TO: Khadeja Sarwar, Atwell, LLC
FROM: Amber Wood Hicken, Planner I
DATE: 7/21/25
SUBJECT: Parker Pointe, Black Rock Coffee, Site Plan
Review Comments 03

LOT 4A, PARKER POINTE SUBDIVISION FILING NO. 1, AMENDMENT NO. 1

SITE PLAN FOR

DRAWN BY: K. SARWAR
CHECKED BY: N. SALAZAR
PROJECT MANAGER: N. SALAZAR
JOB #: 24003198
FILE CODE: ##
SHEET NO. C2.00

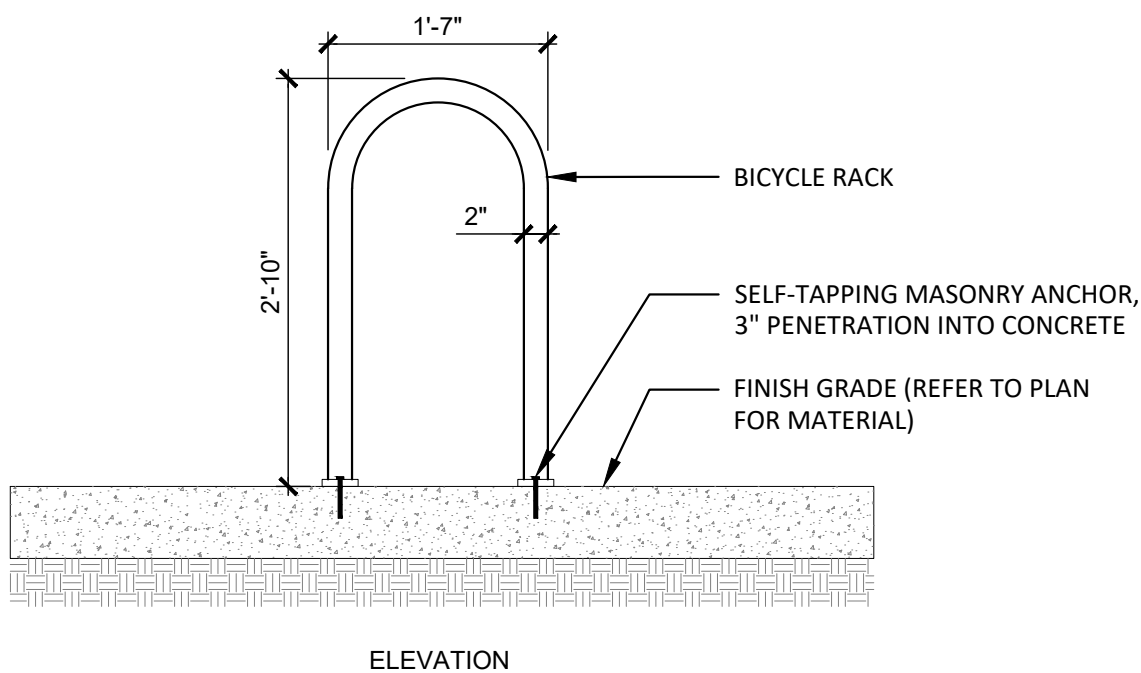
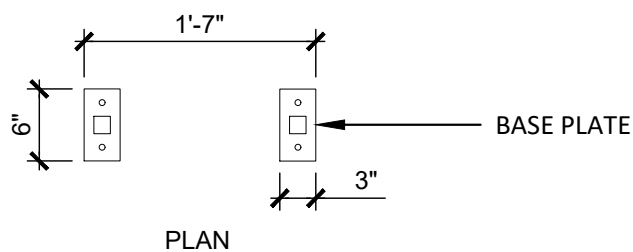
why is transformer being located off-site?

see CORE's comments - transformer location not approved.

show actual setbacks from all property lines (not required setbacks)

label screen wall location on this sheet

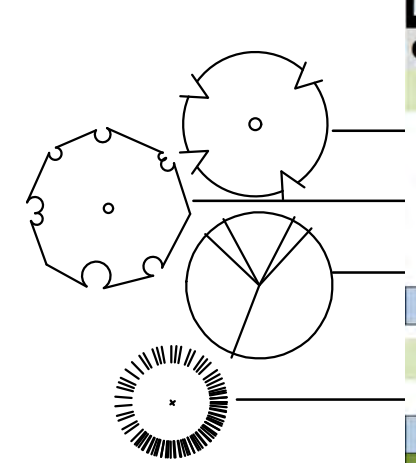
- O. STEEL EDGE INSTALLATION: EDGE SHALL BE ALIGN PERIMETER requirements apply to all perimeters. include east, west
1. STAKE OUT LIMITS OF STEEL CURB OWNERS APPROVAL PRIOR TO INSTALLATION.
2. ALL STEEL CURBING SHALL BE FREE OF KINK BENDS.
3. TOP OF EDGING SHALL BE 2" MAXIMUM HEIGHT FINISHED GRADE.
4. STAKES ARE TO BE INSTALLED ON THE PLAN THE CURBING, AS OPPOSED TO THE GRASS SIDE.
5. DO NOT INSTALL STEEL EDGING ALONG SIDE CURBS.
6. CUT STEEL EDGING AT 45 DEGREE ANGLE WHERE MEETS SIDEWALKS OR CURBS.
7. STAKES ARE TO BE INSTALLED ON THE PLAN THE CURBING, AS OPPOSED TO THE GRASS SIDE.
8. DO NOT INSTALL STEEL EDGING ALONG SIDE CURBS.
9. CUT STEEL EDGING AT 45 DEGREE ANGLE WHERE MEETS SIDEWALKS OR CURBS.

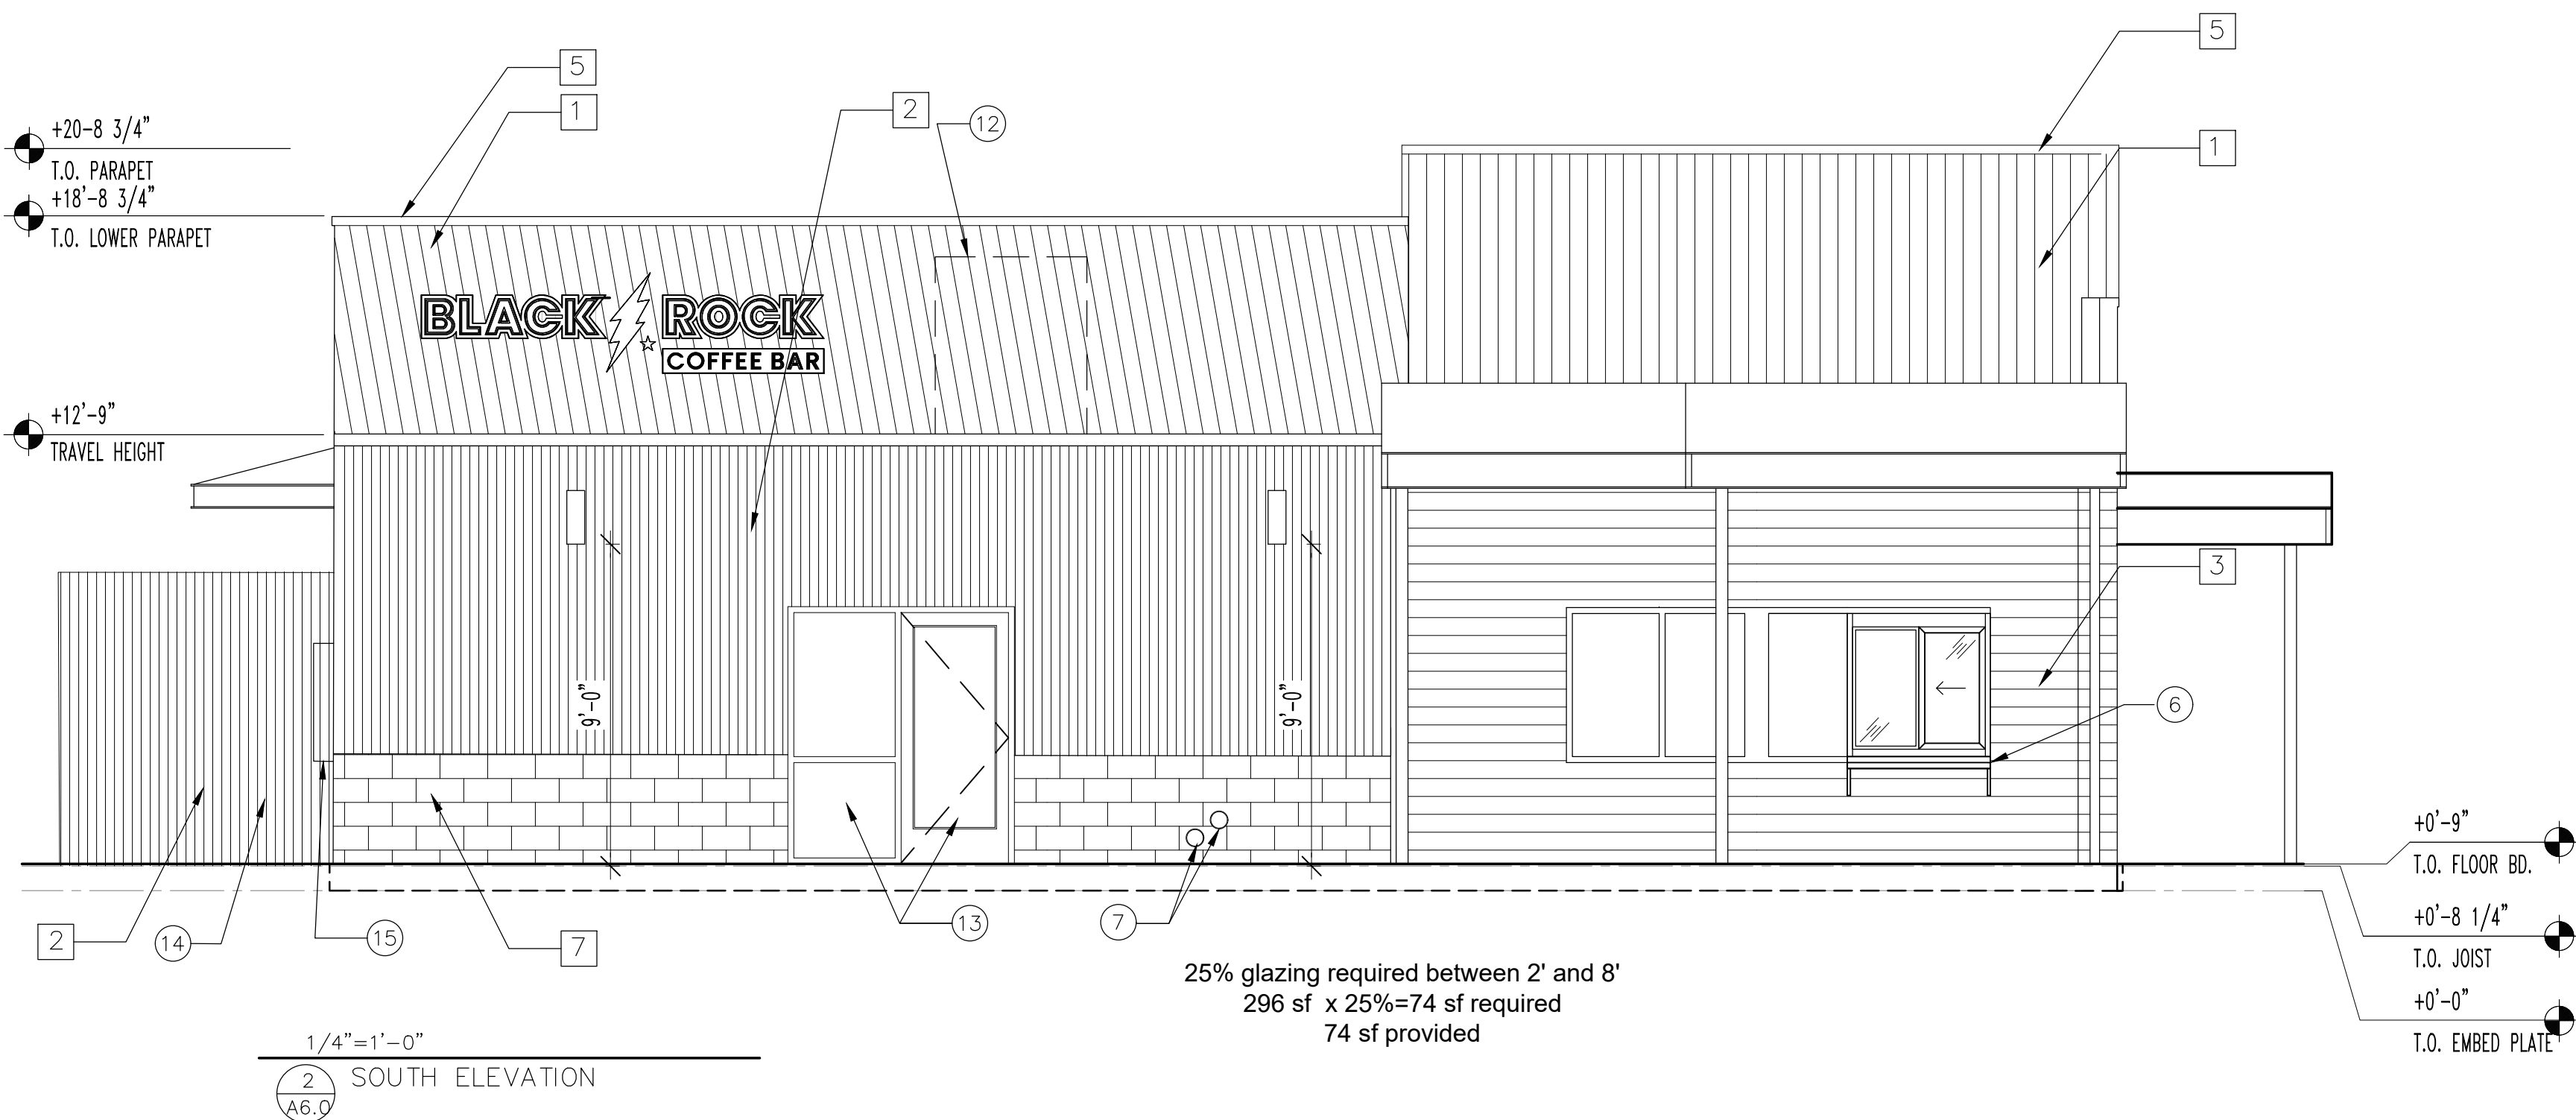
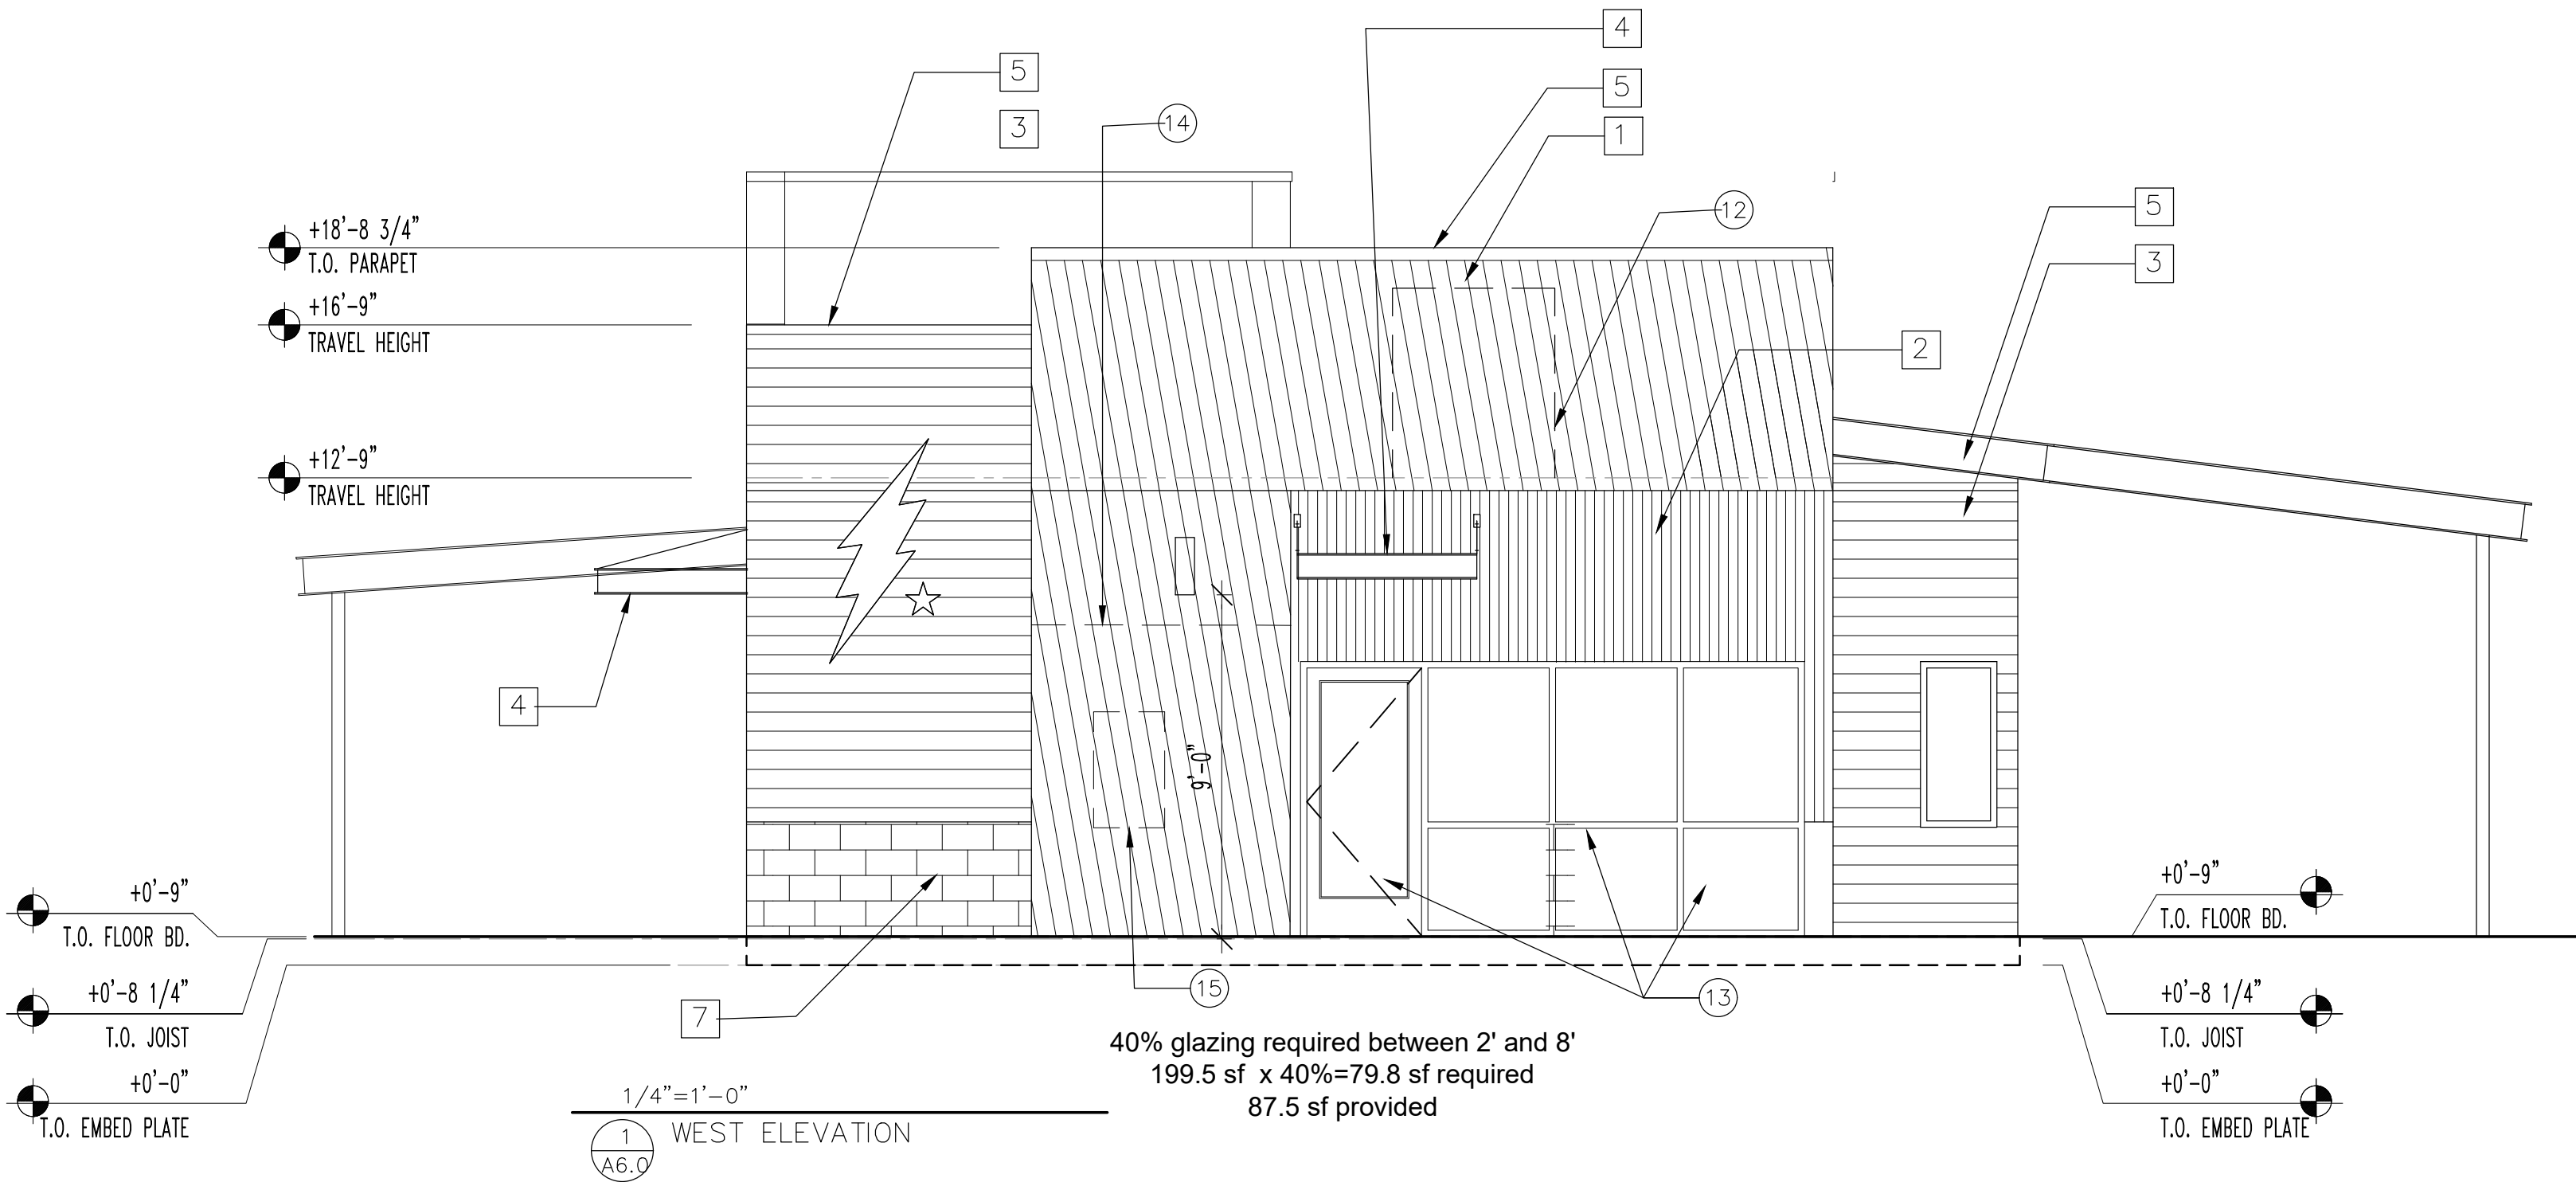
add #15 to all elevation sheets. #13 on some sheets lists electrical equipment
